# UNITED STATES PATENT AND TRADEMARK OFFICE

APPLICATION NO.	FILING DATE	FIRST NAMED INVENTOR	ATTORNEY DOCKET NO.	CONFIRMATION NO.
10/626,209	07/24/2003	Irving W. DeVoe	41056-101	9677
<div>26486      7590      07/02/2008</div> <div>BURNS &amp; LEVINSON, LLP</div> <div>125 SUMMER STREET</div> <div>BOSTON, MA 02110</div>				
EXAMINER				
MENON, KRISHNAN S				
ART UNIT		PAPER NUMBER		
1797				
MAIL DATE		DELIVERY MODE		
07/02/2008		PAPER

### Office Action Summary

### DETAILED ACTION

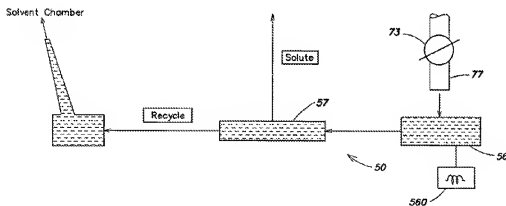
Claim 57 as amended 3/12/08 recite that the vacuum created in the solvent (first) chamber due to osmosis of solvent from the first chamber to the second chamber is utilized to lower the vapor pressure of a mixture of solvent and solute solution to aid in crystallization of the solute solution upon the application of an external energy source. Upon reading through the entire specification as originally filed, it is observed that page 18, line 3, - page 19, line 8, and figure 5 provides the closest disclosure to claim 57. Figure 6 combines figure 5 with the osmotic power conversion system. Lines 15-17 of page 8 discloses that *in the illustrated configuration* [by figure 5], *the blow down receiving chamber 56, the condenser 57 and the solvent chamber 20 are hermetically*

joined and the internal space throughout is under vacuum or near the vapor pressure of the solvent. However, figures 5 and 6 are grossly inadequate and does not provide any details of how the receiving chamber, the condenser and the first (solvent) chamber are linked together to keep them under vacuum generated by the first (solvent) chamber. There is no showing of how the vacuum generated in the first (solvent) chamber is utilized in maintaining a vacuum in the solvent condenser (57) and the blow-down chamber (56). The line from the solvent condenser to the osmosis unit (30) is labeled as transferring solute, and it goes to the solution chamber. The closed loop in figure 9 only provides a liquid line from the condenser to the solvent chambers 20 b and c. Since this vacuum generated in the solvent chamber by osmosis aiding the crystallization of the solute from the solute solution is an essential part of the claimed invention, the claims are not enabling. Figures 5,6 and 9 are reproduced below:

FIG. 6

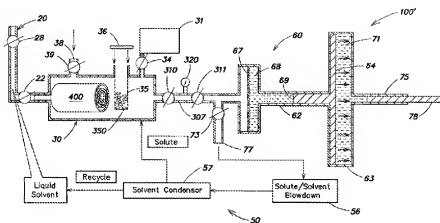
- The volume increased in the solution chamber is the volume of solvent migrated through the membrane. This volume increase in the solution chamber would generate a huge pressure increase in the solution chamber because the solution (or liquid) is comparatively incompressible. In applicant's figure 6, this would result in pushing the

piston forward in the reciprocating engine. When the expansion is complete (or available sweep volume for the piston is exhausted), the system must reverse and divert the increased solution volume into the blow-down chamber.
